State of Hawaii
DEPARTMENT OF LAND AND NATURAL RESOURCES
ENGINEERING DIVISION
1151 Punchbowl Street, Room 221
Honolulu, Hawaii 96813

ADDENDUM NO. 2

Job No. F48C612A
Keaiwa Heiau State Recreation Area Water System Improvements
Aiea, Hawaii

May 19, 2026

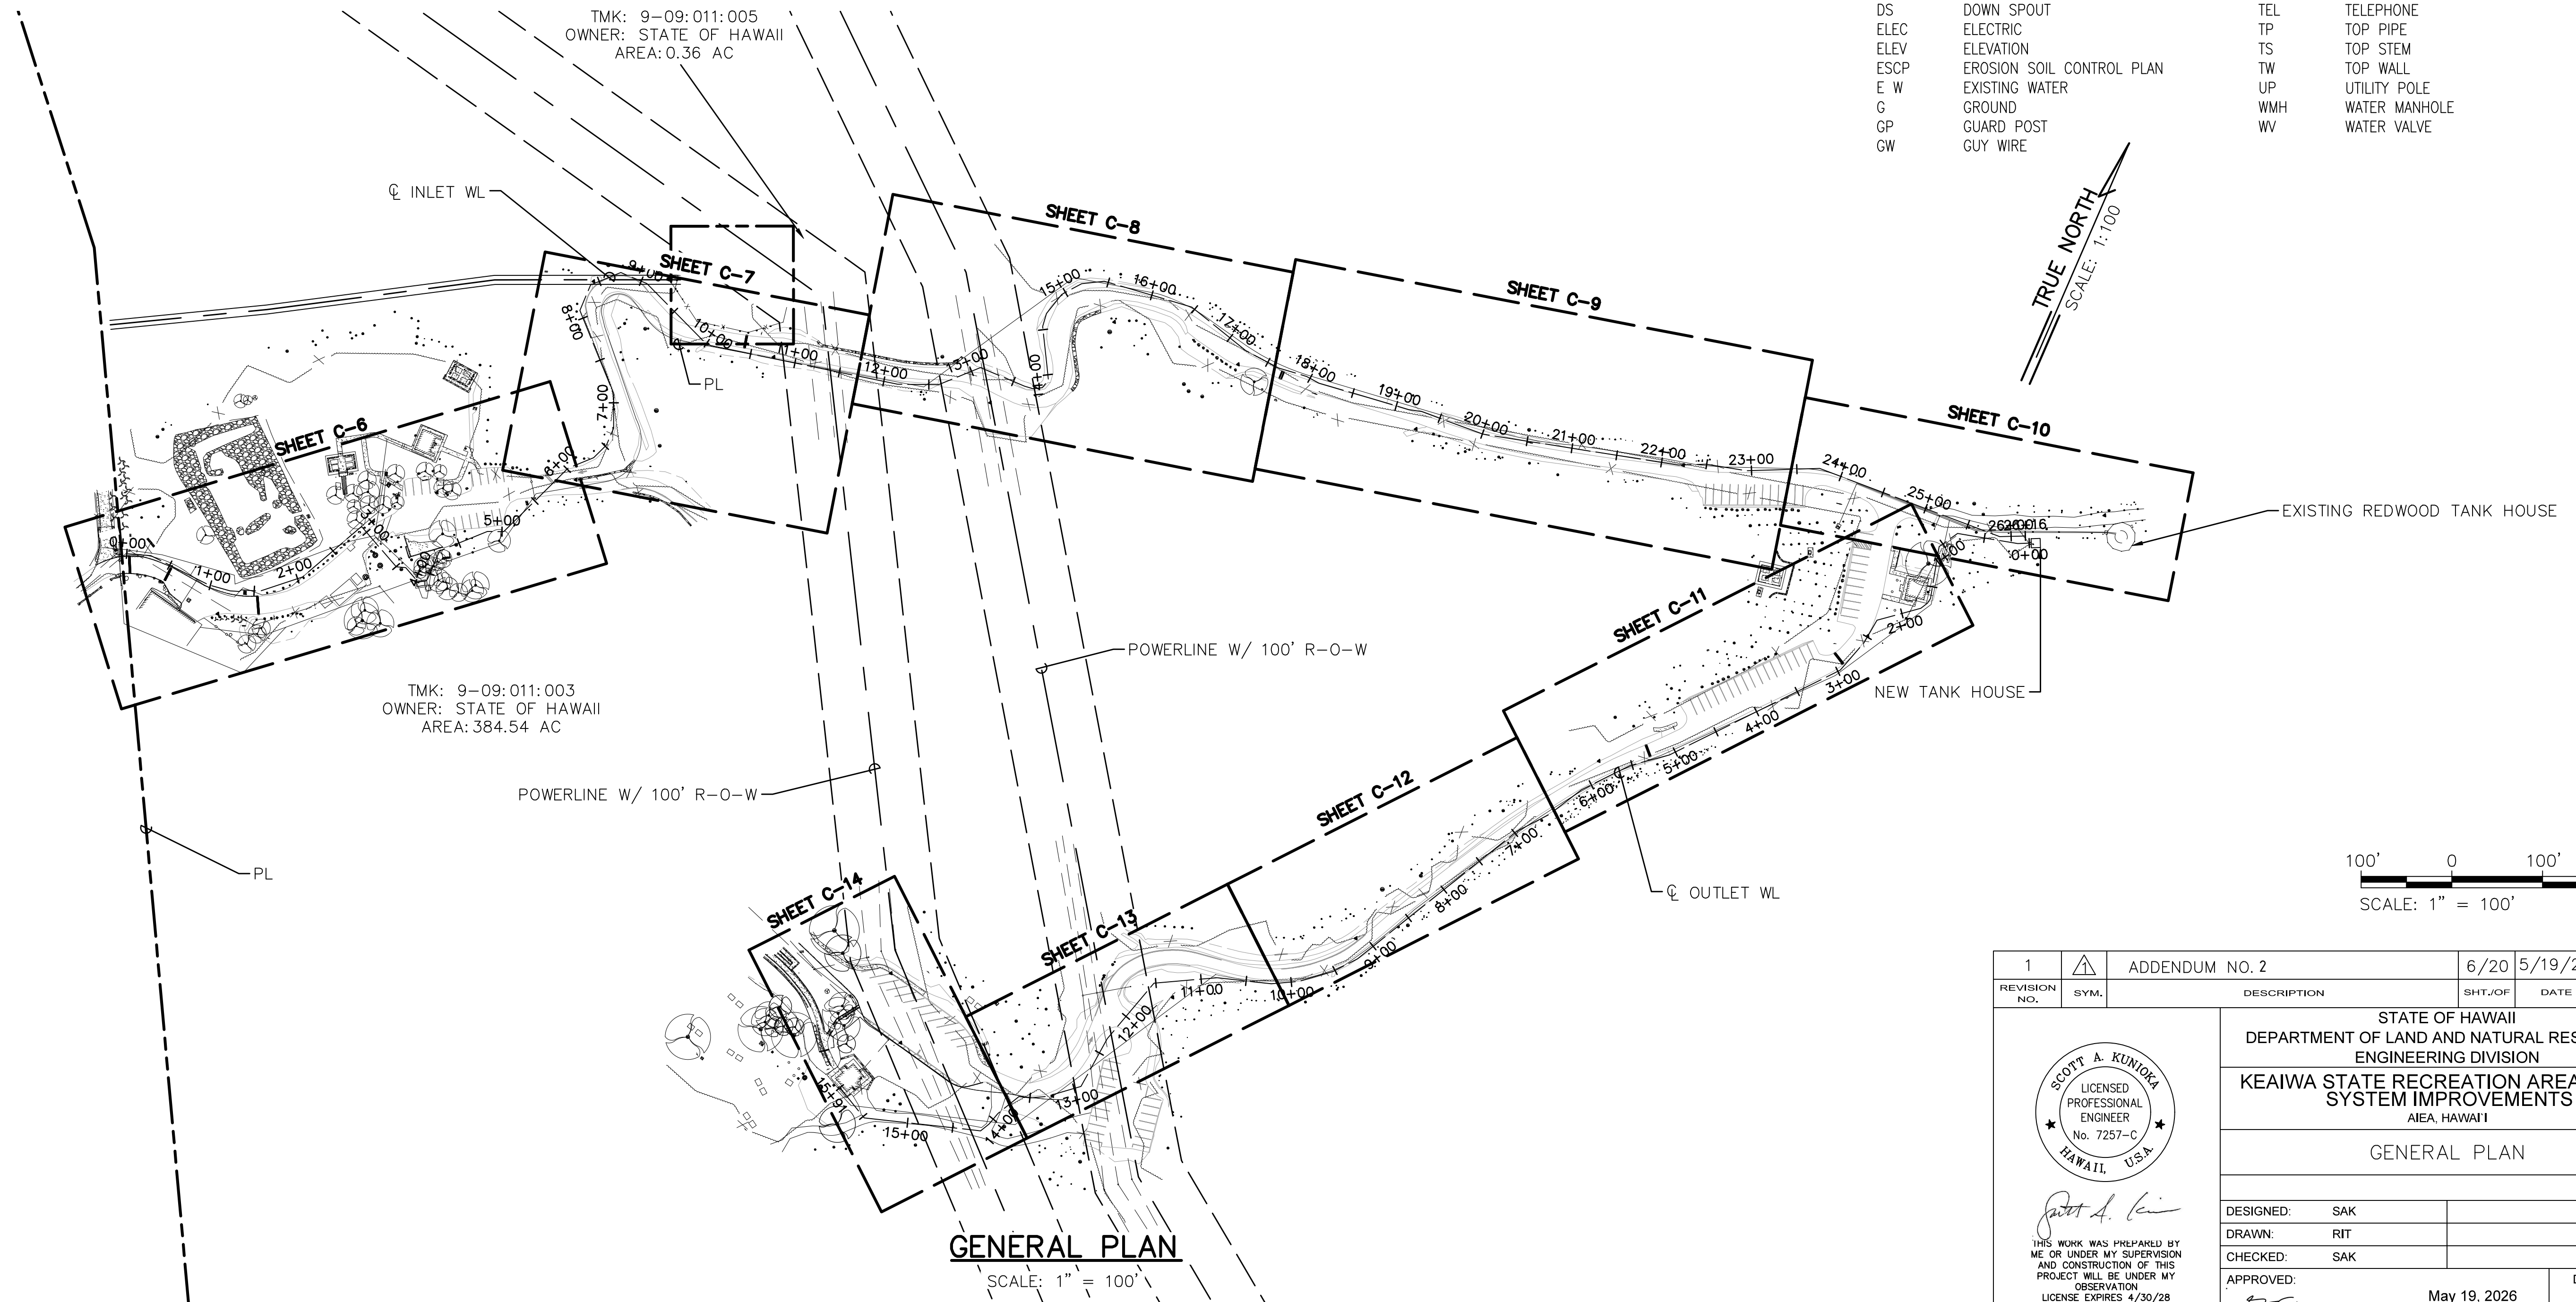
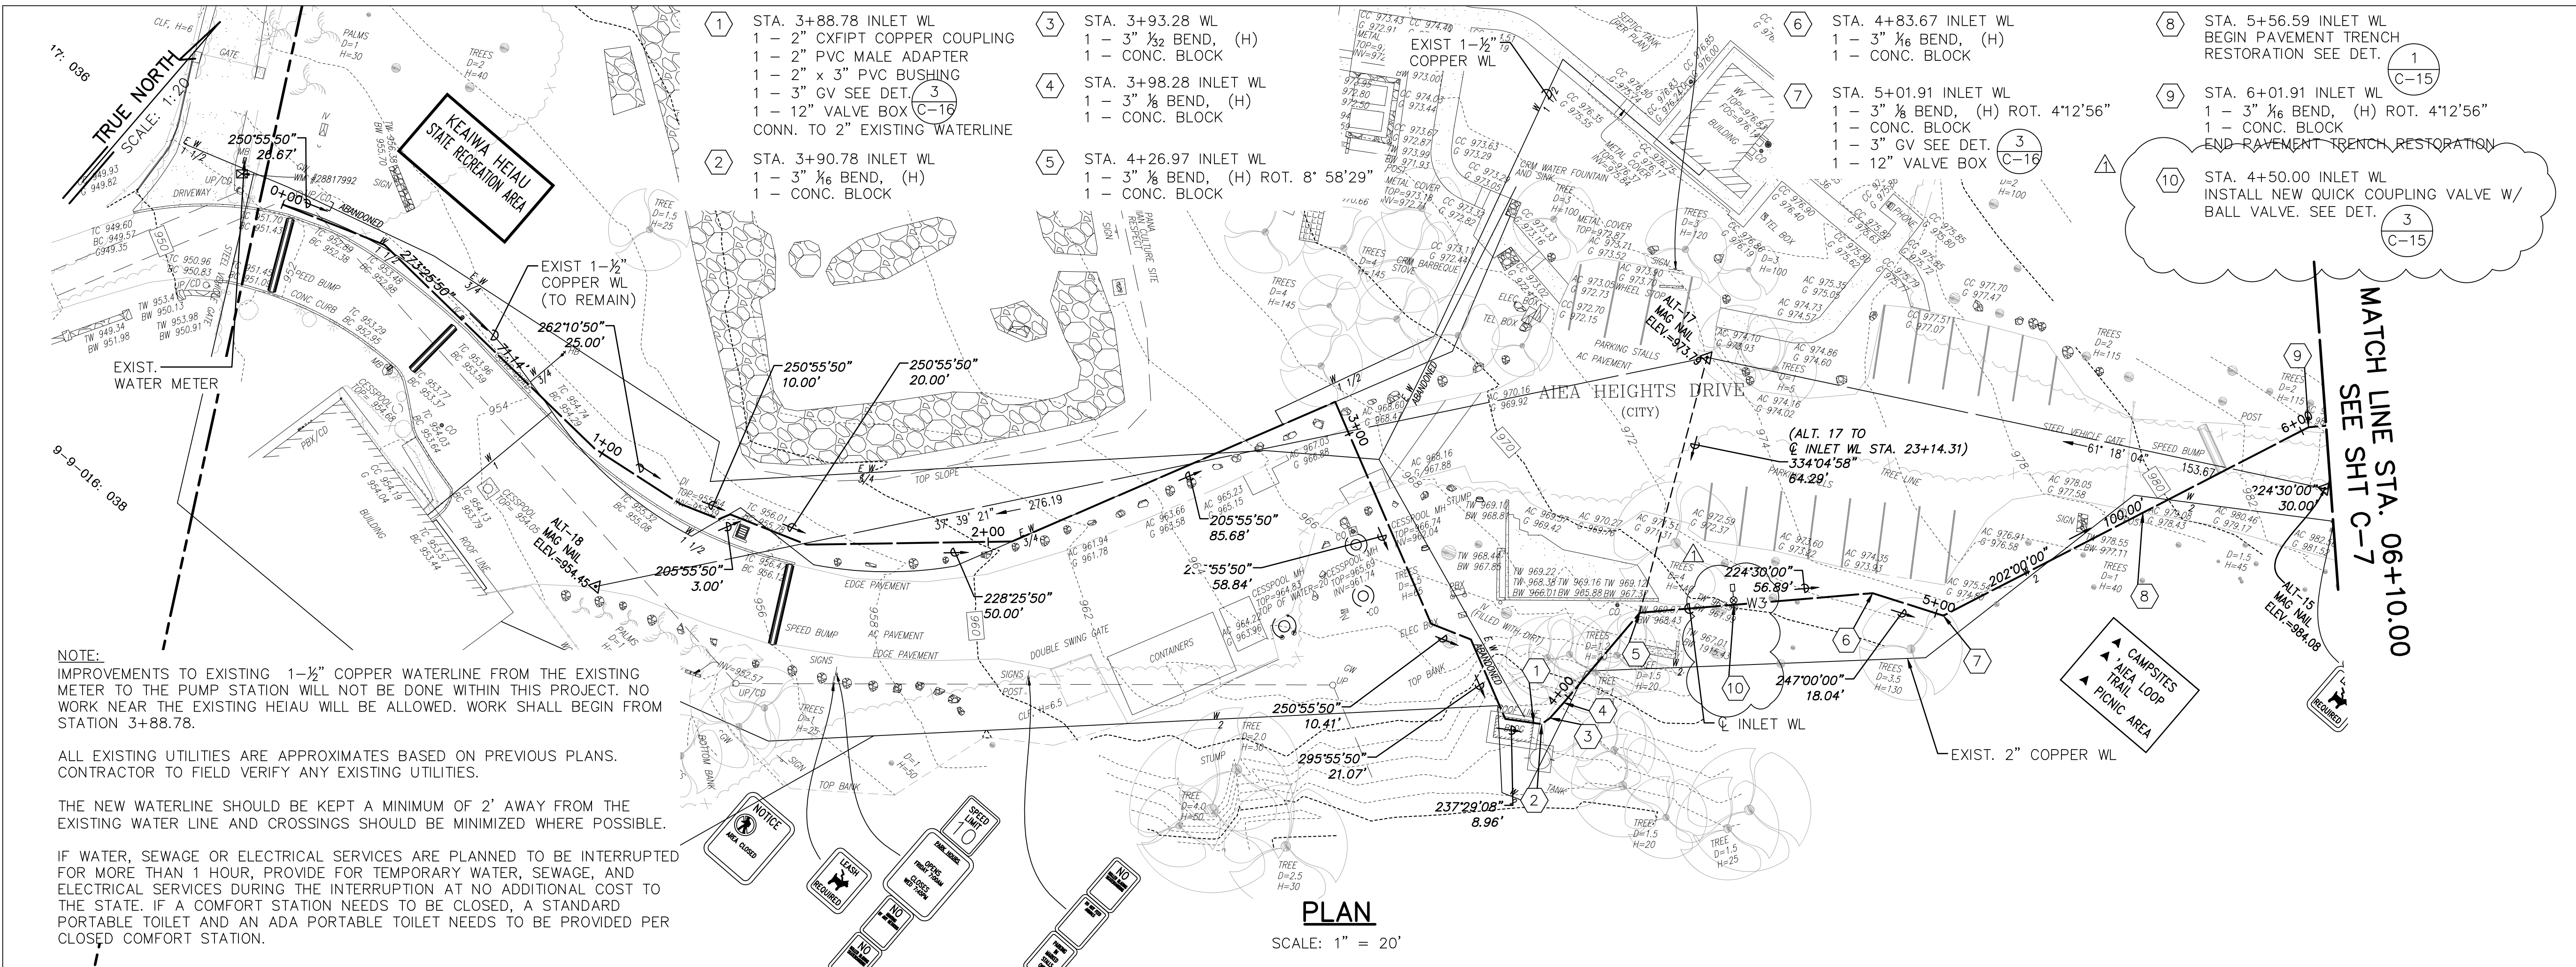
1. Sheet C-5 – General Plan, Replace sheet with the attached Sheet C-5.
 - a. Added Note 14.
2. Sheet C-6 – Plan & Profile 1, Replace sheet with the attached revised Sheet C-6.

14. EXISTING WATERLINE SHALL BE KEPT IN CONTINUOUS SERVICE AT ALL TIMES DURING CONSTRUCTION. THE CONTRACTOR SHALL NOT INTERRUPT SERVICE UNTIL THE NEW WATERLINE IS FULLY INSTALLED, TESTED, DISINFECTED, APPROVED, AND PLACED INTO OPERATION.

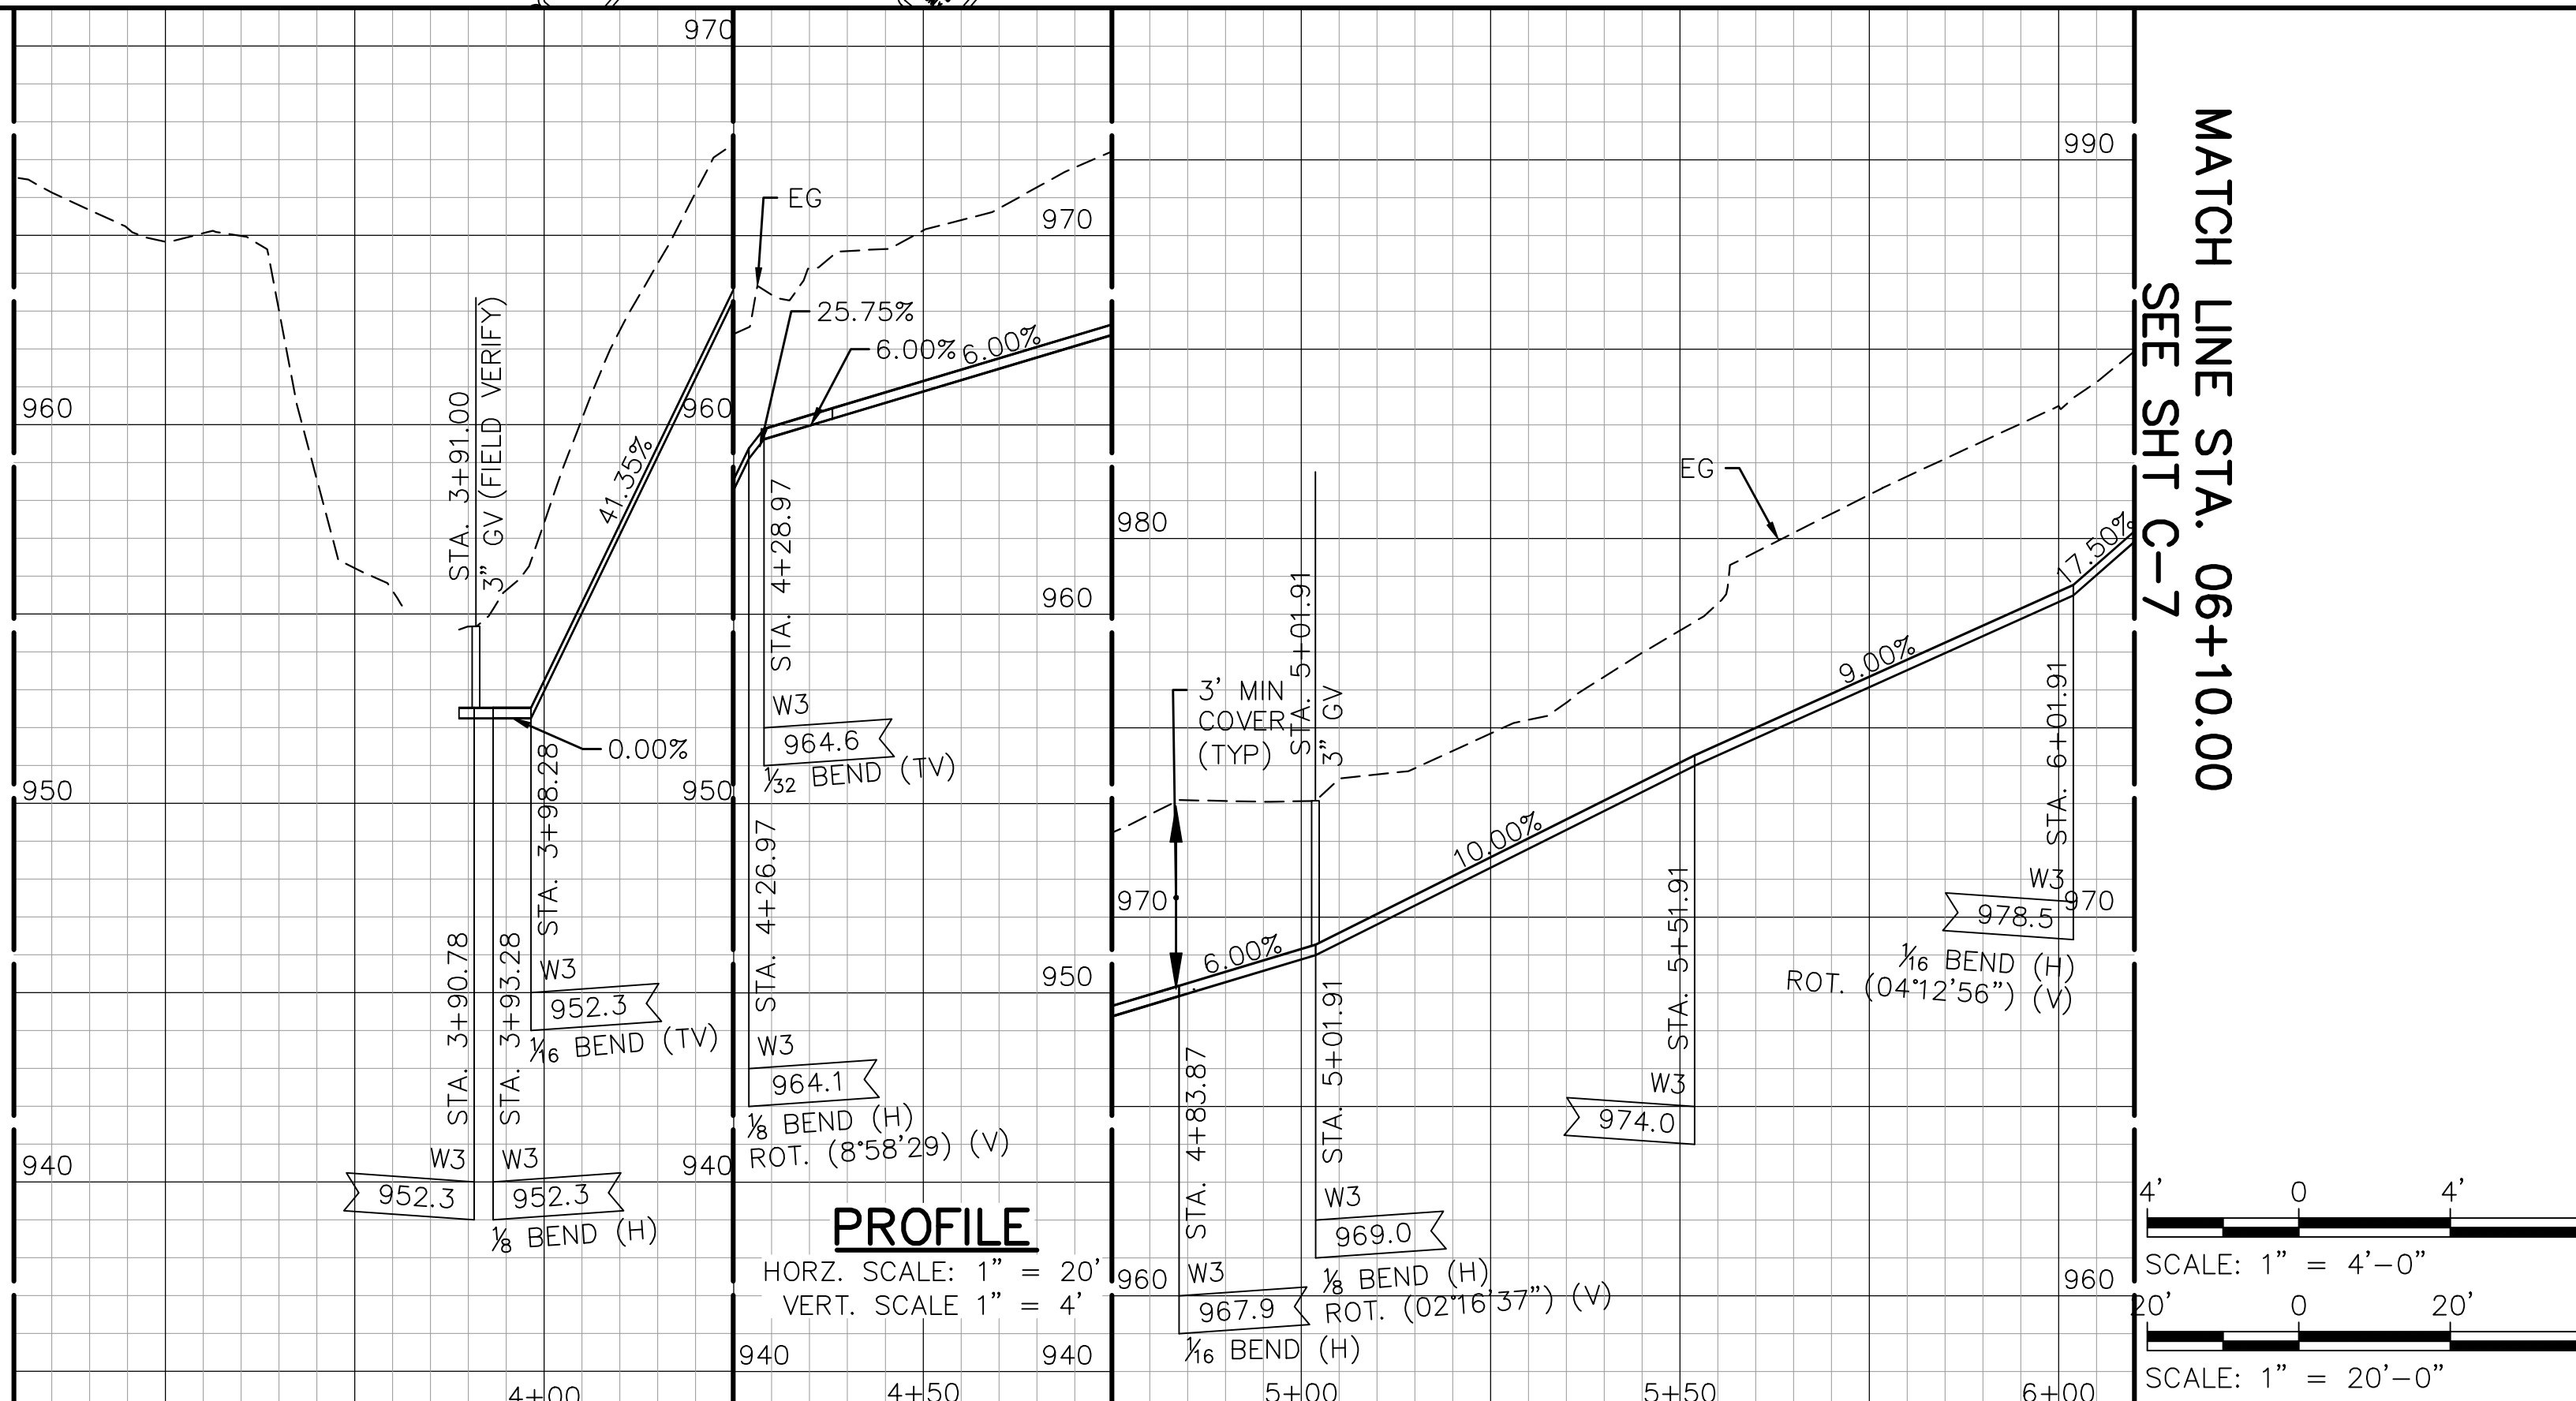
- a. Added new quick coupling valve.
3. Sheet C-7 – Plan & Profile 2, Replace sheet with the attached revised Sheet C-7.
 - a. Added new gate valve and Air relief valve.
